RHODE ISLAND DEPARTMENT OF TRANSPORTATION

Old Tower Hill Rd (Rt 108 - Rt 1)

NOTICE TO PROSPECTIVE BIDDERS

ADDENDUM NO. 2 Prospective bidders and all concerned are hereby notified of the following changes in the Plans, Specifications, Proposal and Distribution of Quantities for this contract. These changes shall be incorporated in the Plans, Specifications, Proposal and Distribution of Quantities, and shall become an integral part of the Contract Documents.

2. Plan Sheet 40

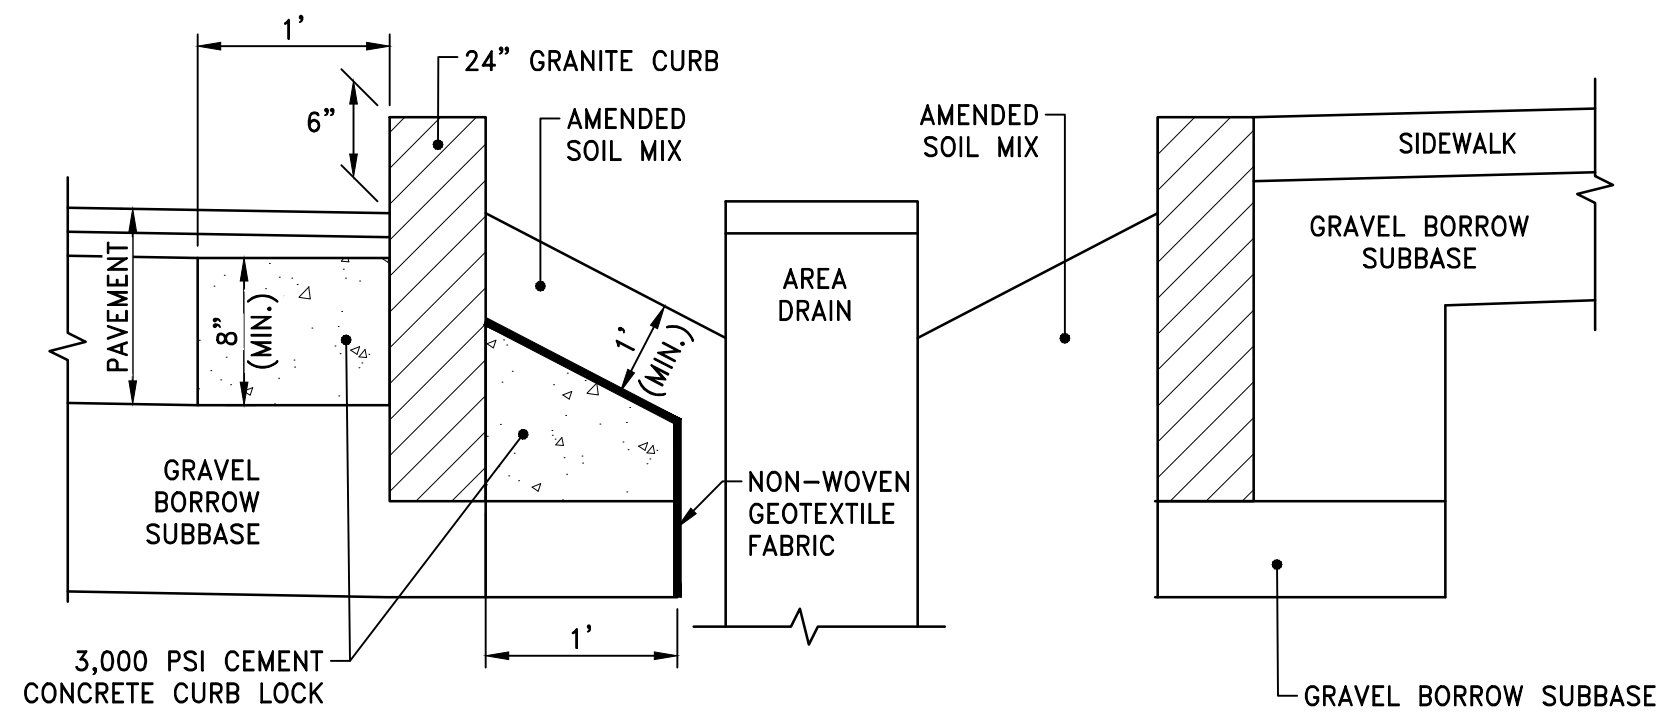
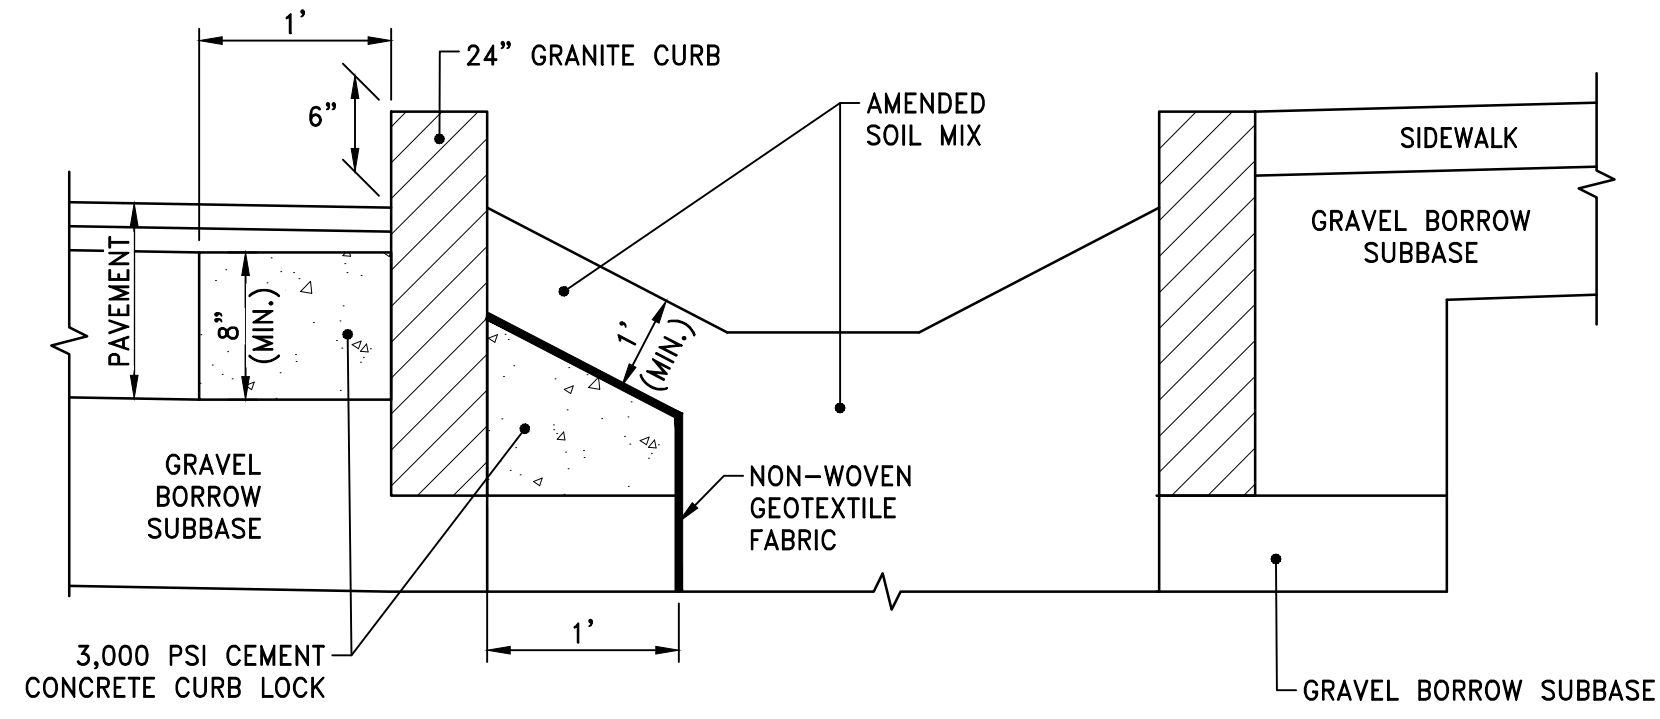
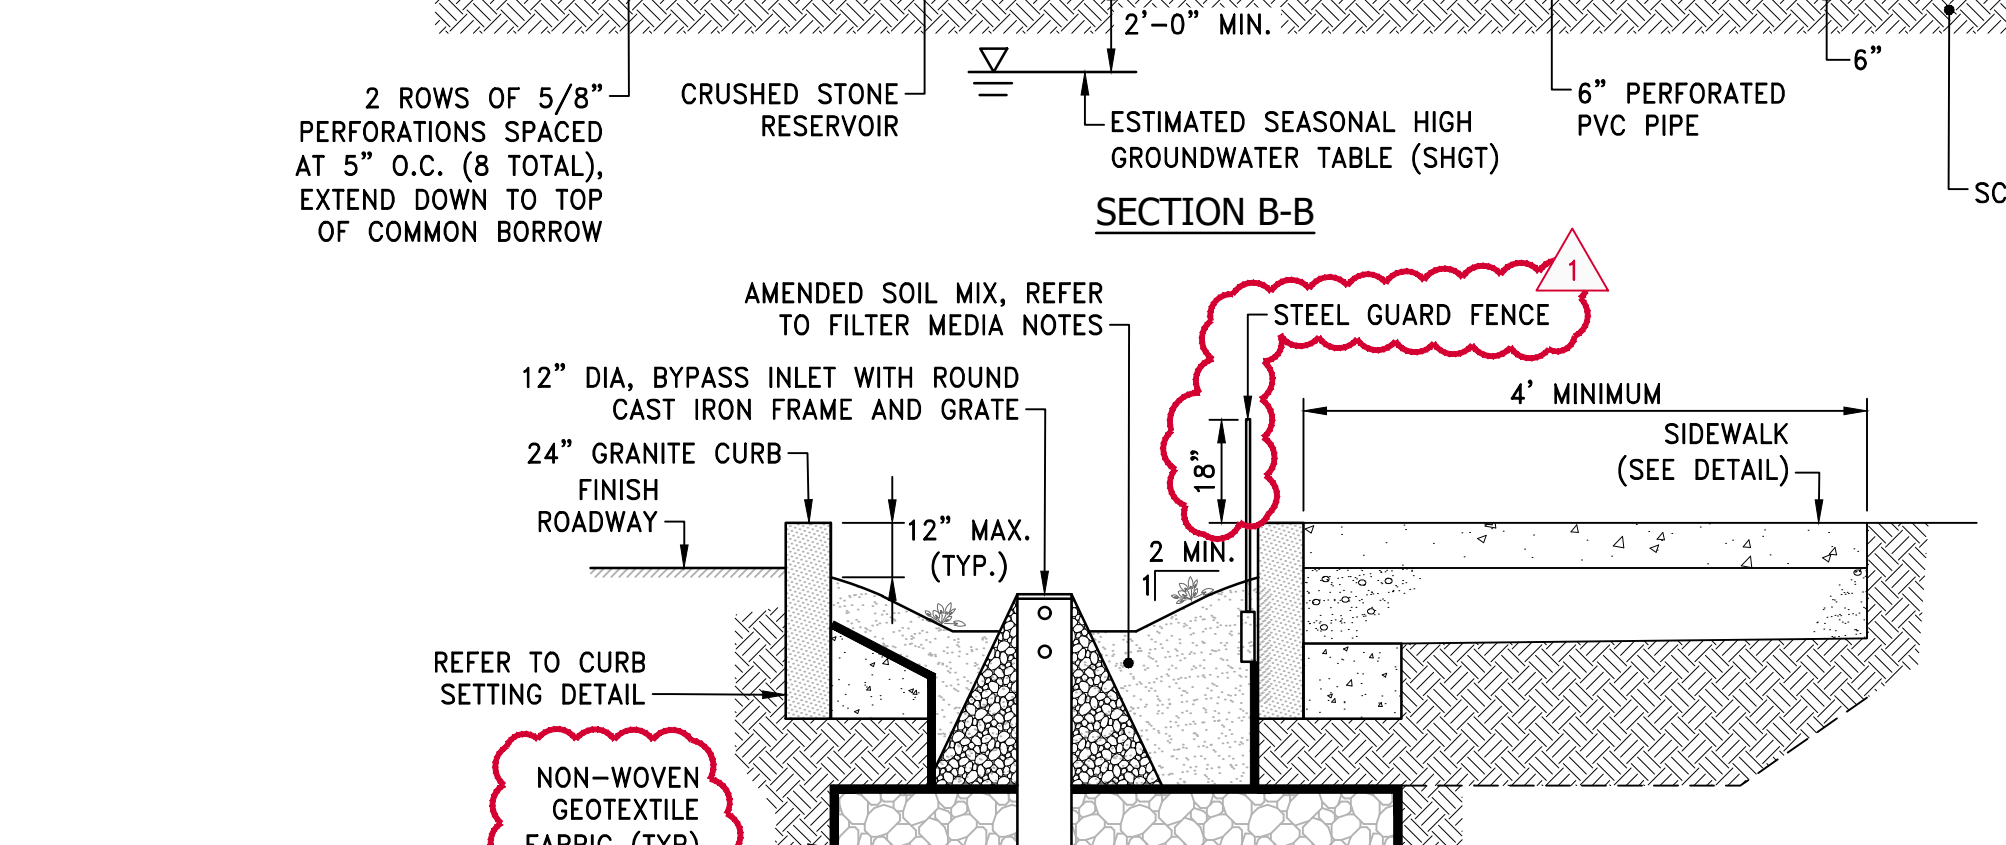
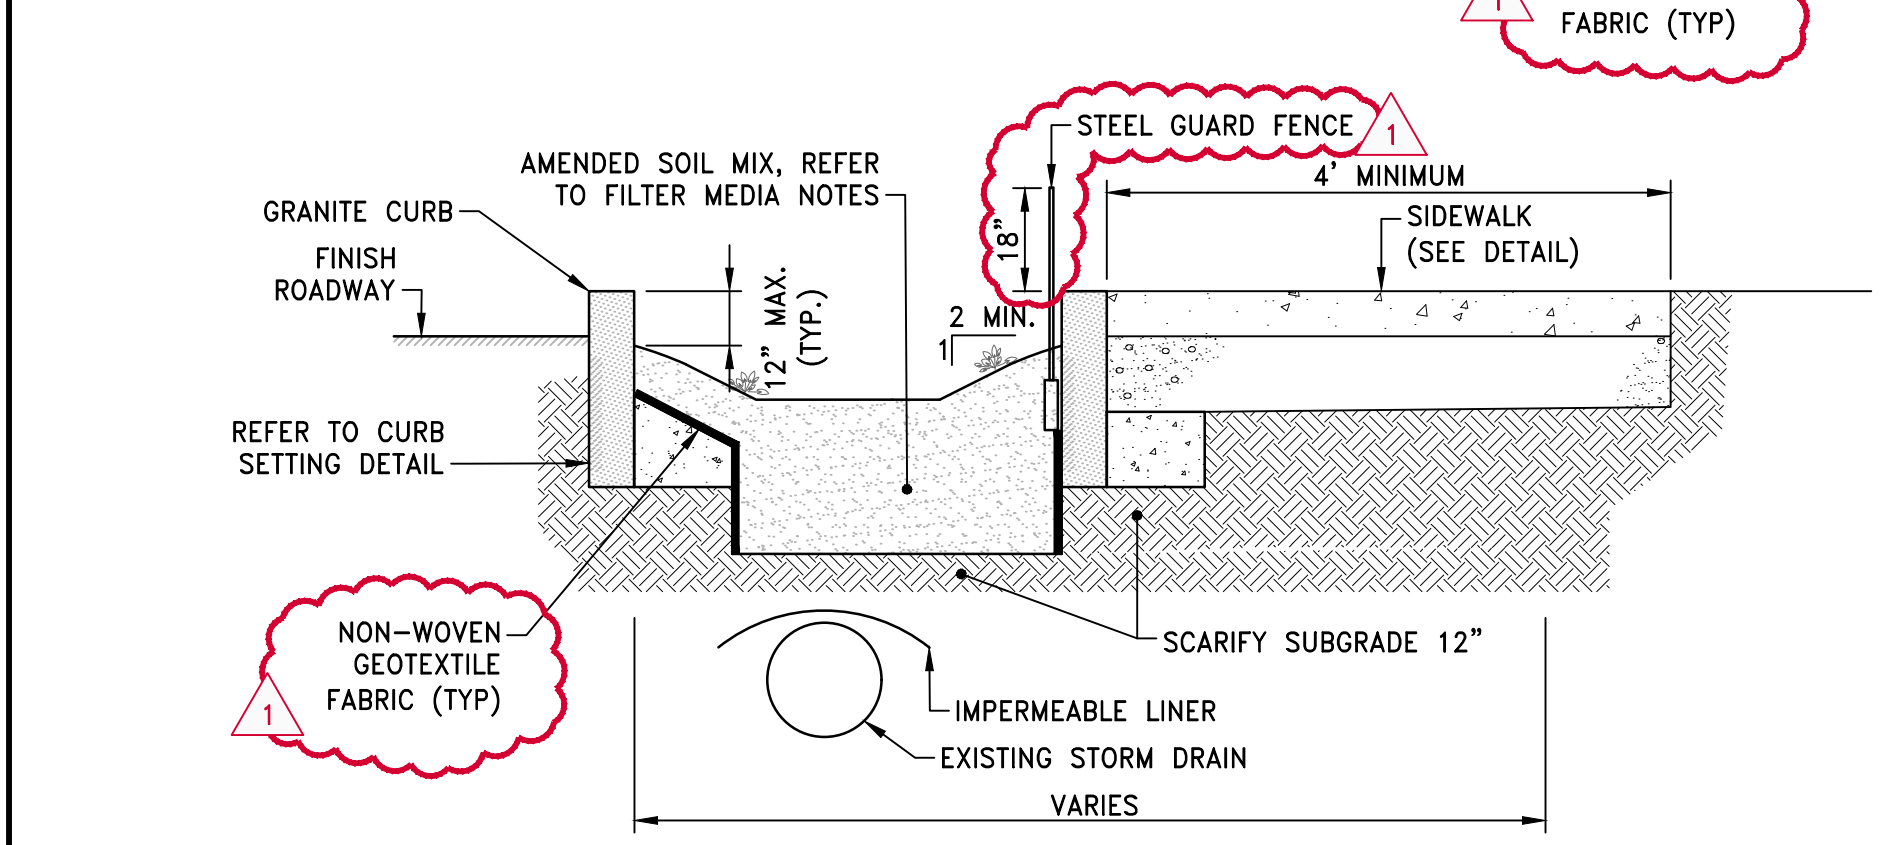
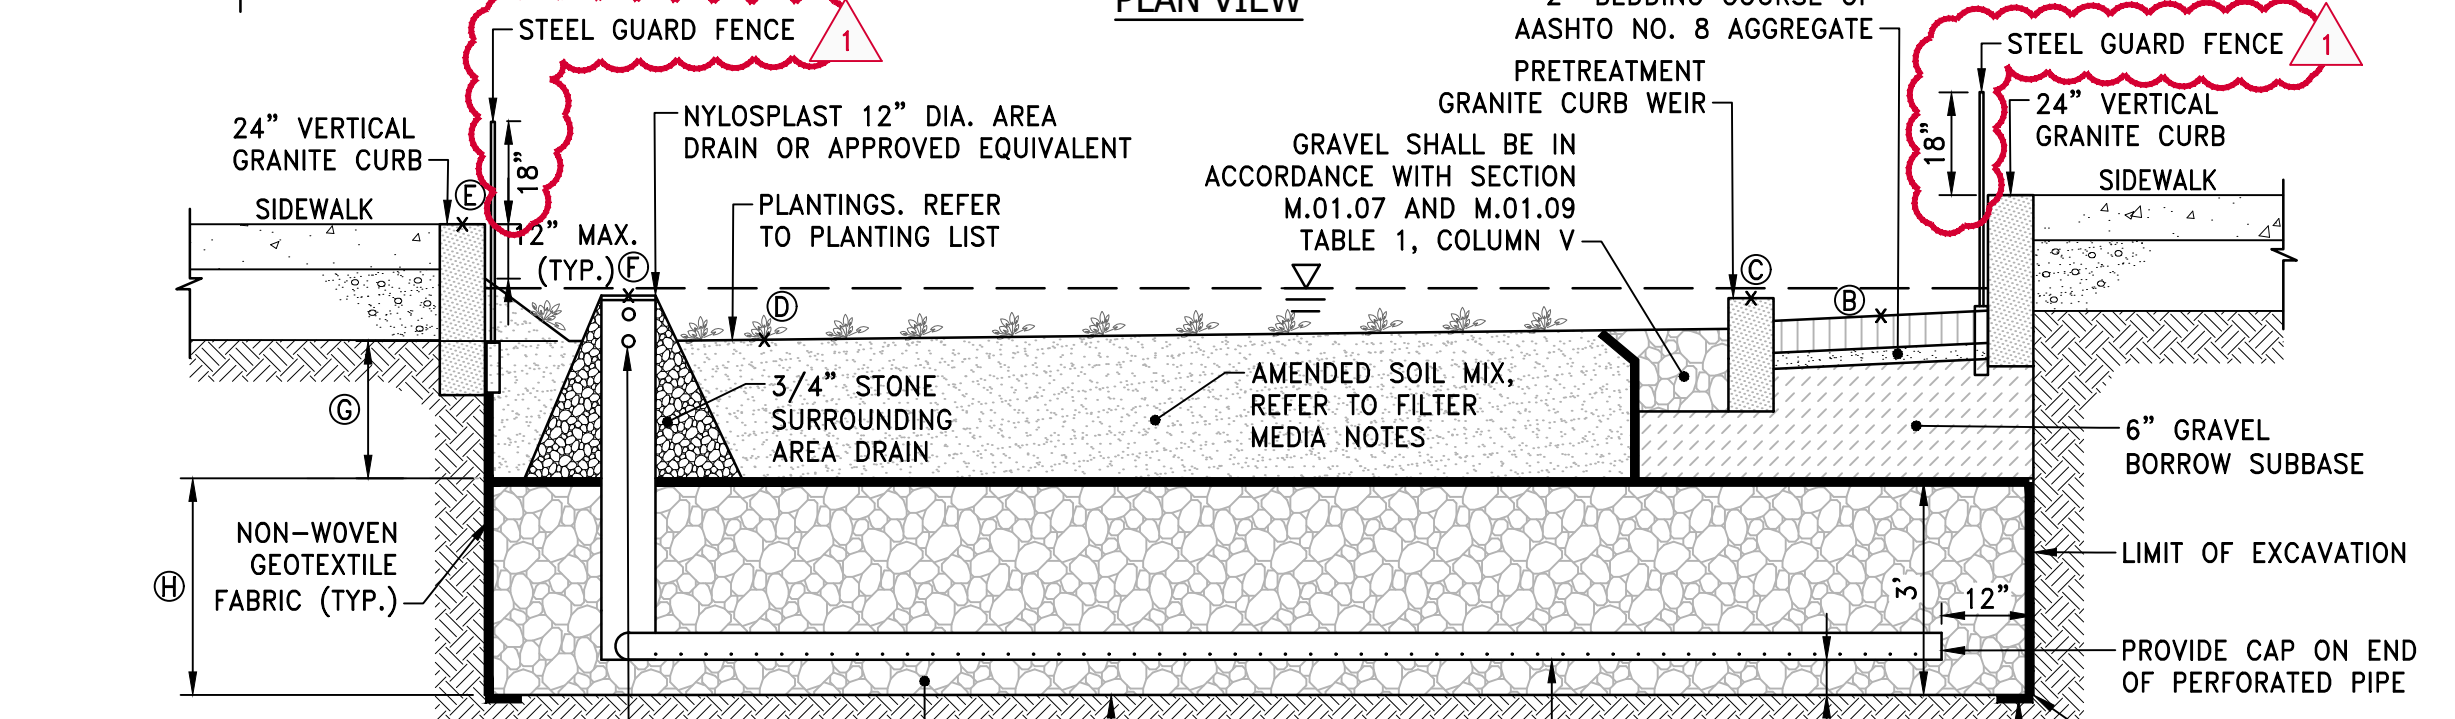
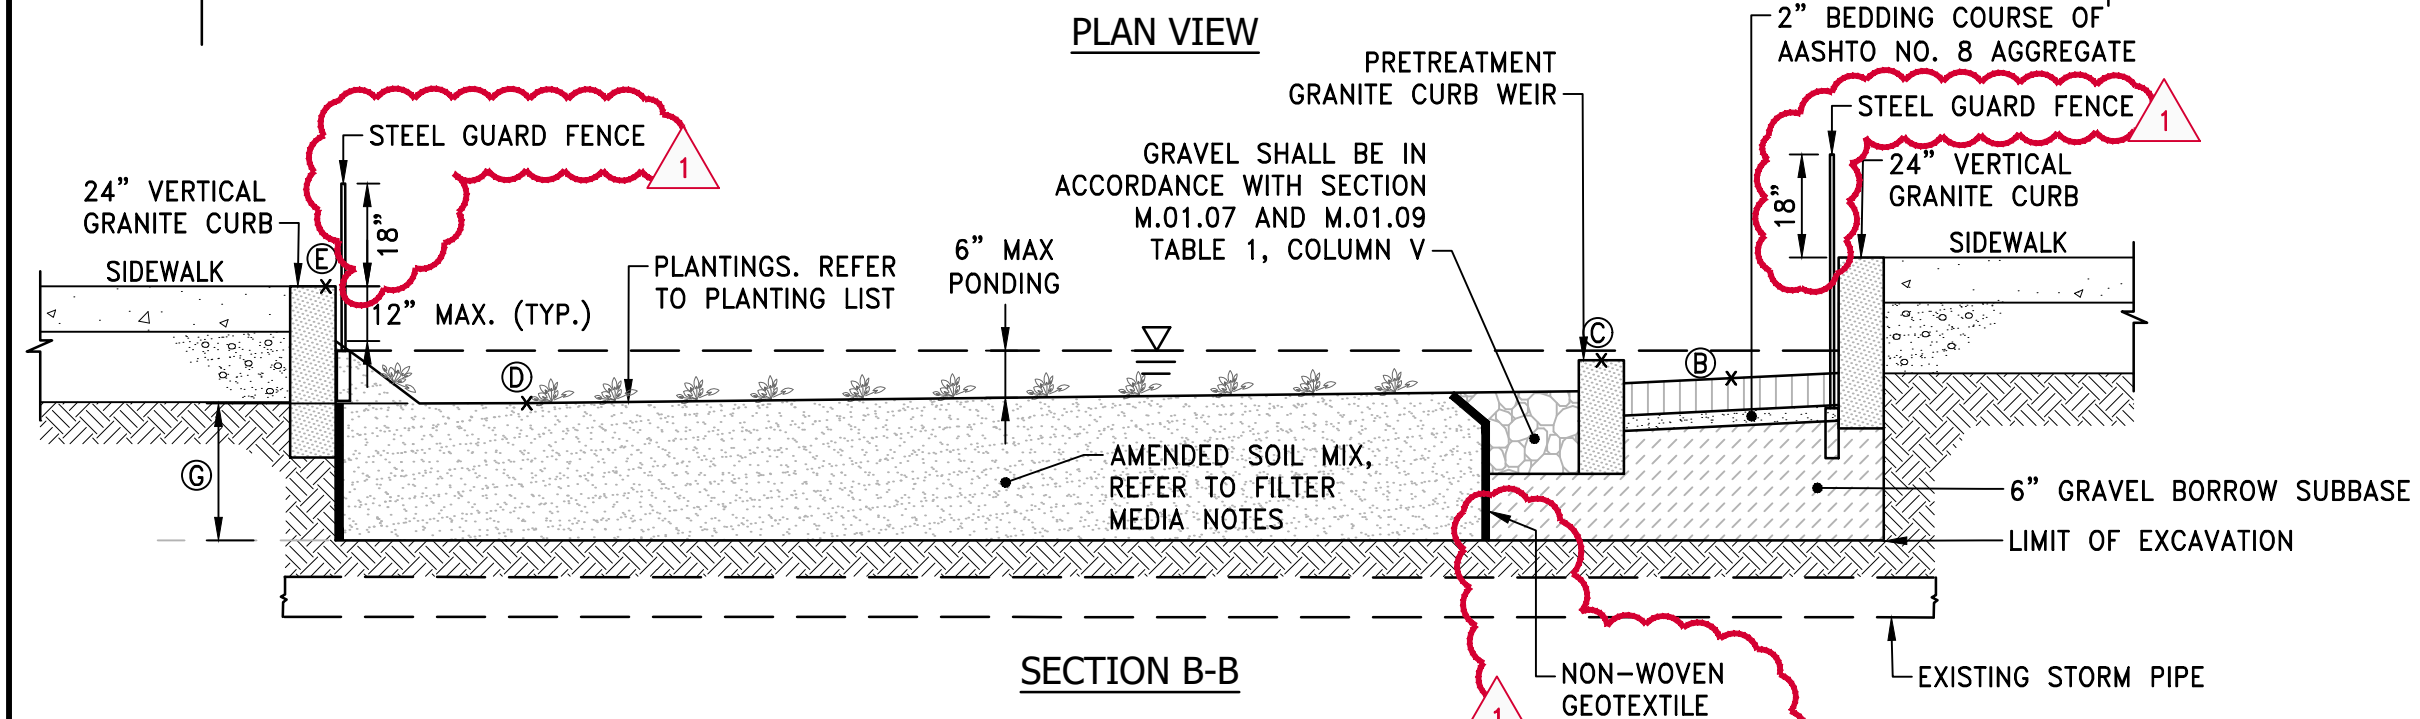
Replace Plan Sheet 40 with Sheet 40(R-1) attached to this Addendum No. 2. The bioretention curb inlet planter details have been modified.
